# PHASE I INSPECTION REPORT

## NATIONAL DAM SAFETY PROGRAM

APRIL 1981

NAME OF DAM: STEERS MILL DAM  
LOCATION: DINWIDDIE COUNTY  
INVENTORY NUMBER: VA. NO. 05302

STRUCTURAL CRACKING  
AT COUNTERFORT NO. 3

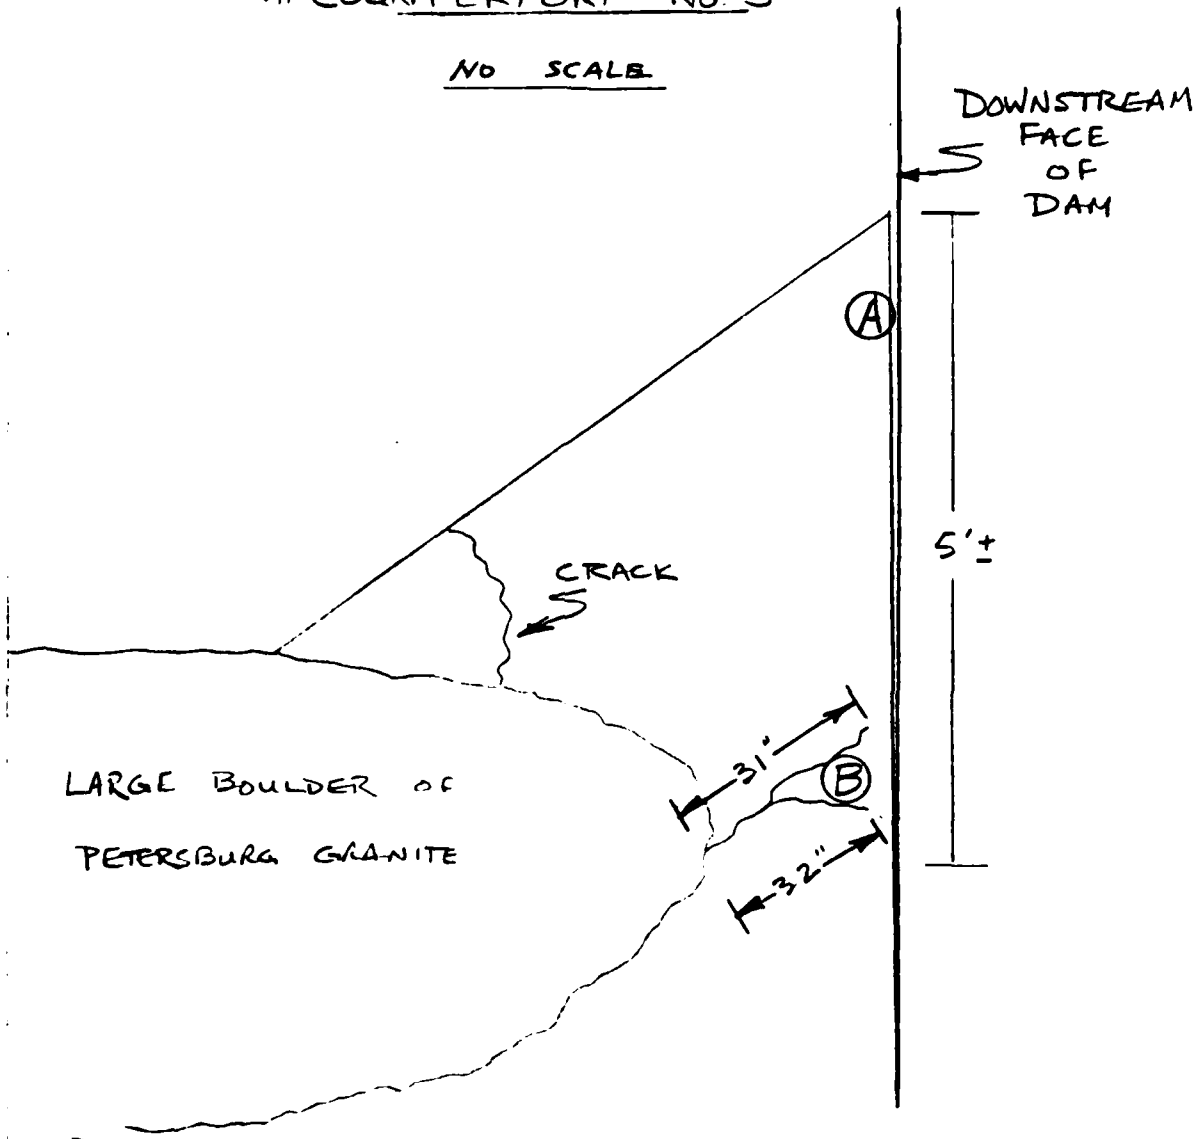
studies and design work. The structural cracks observed in the counterforts (particularly No. 3) should be examined during this study and repairs made as determined necessary.

- Ⓐ UPPER 5 FT OF COUNTERFORT SEPARATED FROM DAM 1 - 3 INCHES ±
- Ⓑ STUCK RULER INTO THE 31 INCH CRACK, TO DEPTH OF 8 INCHES

7.2.1 Perform a stability analysis in order to evaluate the stability of the dam and modify as necessary. The owner should engage the services of a qualified Professional Engineering firm with expertise in Geotechnical and Structural Engineering to perform necessary
